UNITED STATES PATENT AND TRADEMARK OFFICE

APPLICATION NO.	FILING DATE	FIRST NAMED INVENTOR	ATTORNEY DOCKET NO.	CONFIRMATION NO.
09/582,634	09/13/2000	Shirwan Alpasha Al Bahdaini		5682

Office Action Summary	Application No.	Applicant(s)	
	09/582,634	AL BAHDAINI, SHIRWAN ALPASHA	
	Examiner	Art Unit	
	Thai-Ba Trieu	3748

DETAILED ACTION

Projectile motion

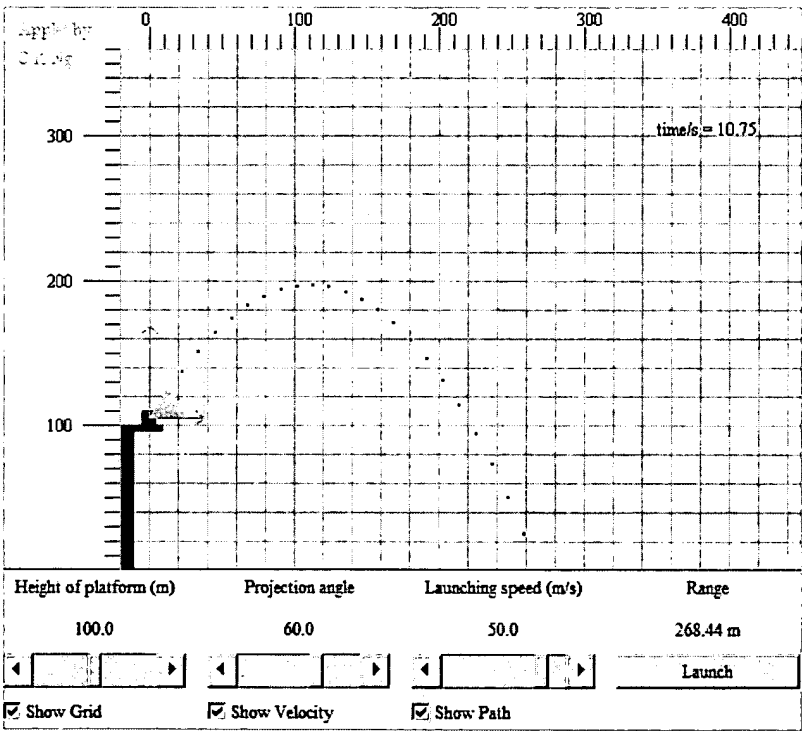
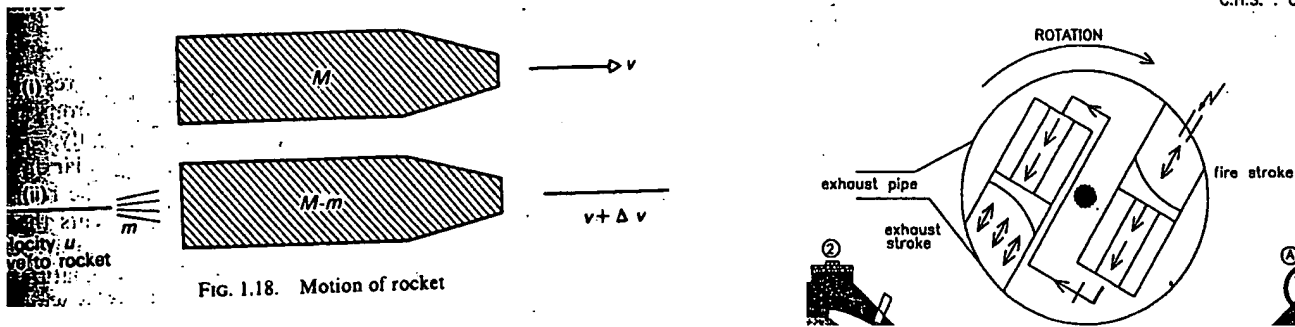
Examiner respectfully disagrees with the applicant, since the applicant has applied the concept of using a black powder explosion for guns to throw projectile bodies in explaining the rotation movement of the flywheel with substituting the projectile body by an elastic traveling piston to allow gases to expand or partially released causing impulse. How can a projectile movement of a body be related to the rotational movement of a flywheel/rotor? By the definition, projectile motion

refers to the motion of an object projected into the air at an angle. A few examples of this include a soccer ball begin kicked, a baseball begin thrown, or an athlete long jumping. Even fireworks and water fountains are examples of projectile motion.
